AMENDMENT NO. 1 MARCH 1989
TO
IS : 11002 - 1984 SPECIFICATION FOR MACHINE JIG REAMERS
MORSE TAPER SHANK

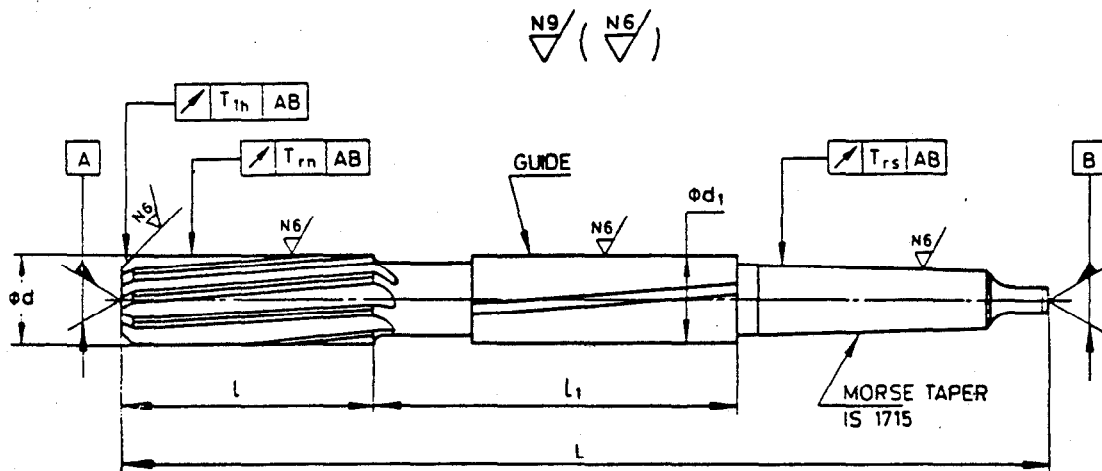
(Page 2, Table 1, figure) — Substitute the following for the existing figure:
